**Development Application DA2025/1101
Issues Response/ Supplementary Statement of Environmental Effects
Demolition works, construction of multi-dwelling housing (terraces) and
subdivision of one lot into 3 lots
12 Nailon Place, Mona Vale**

Reference is made to Councils issues letter of 2nd October 2025 in which a number of issues were raised. This supplementary statement of environmental effects details the considered response to the issues raised and is to be read in conjunction with the following amended/additional plans and documentation:

Figure 1 - LMR indicative mapping tool showing maximum 693 metres walking distance from the site along public footpaths to land identified as Mona Vale Town Centre.

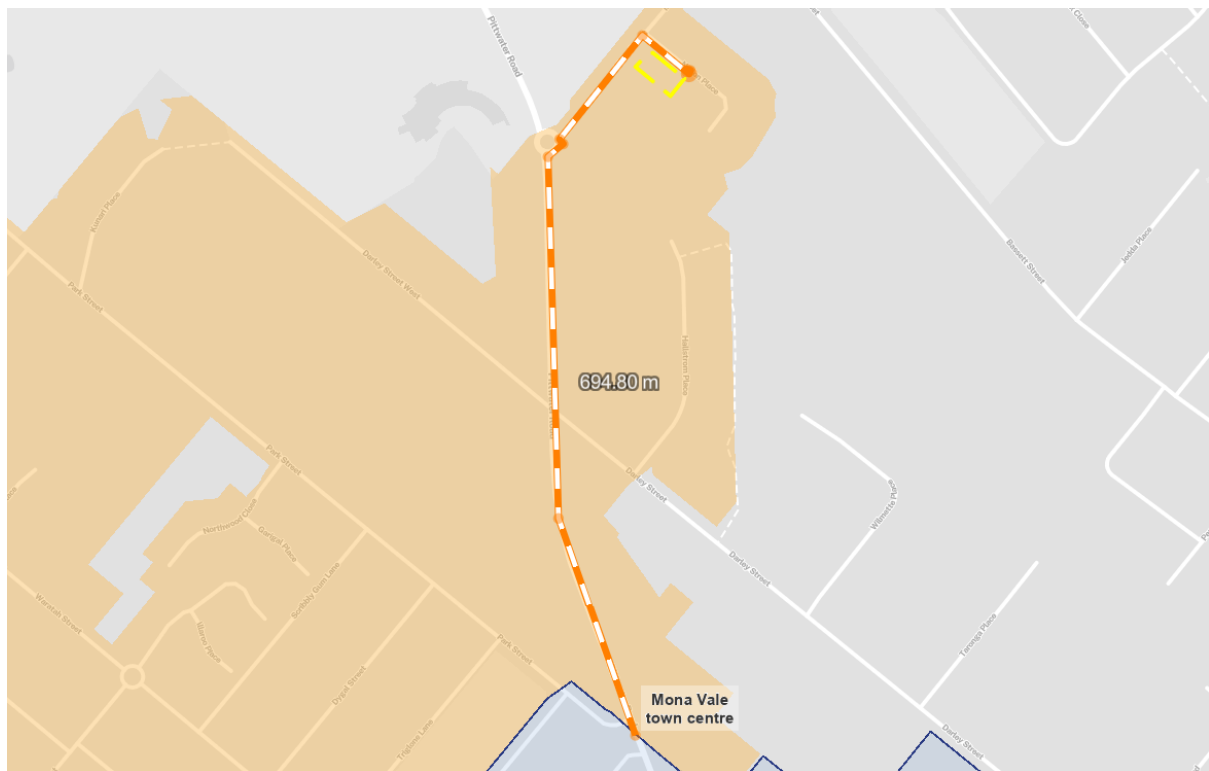
2. Low and Mid-Rise Housing Area

Response: We confirm that the entire property is located within 693 metres walking distance of land identified as Mona Vale Town Centre on the indicative LMR map as detailed below. Accordingly, the Chapter 6 LMR provisions of SEPP Housing are applicable to development on the land.

This issue has been resolved.
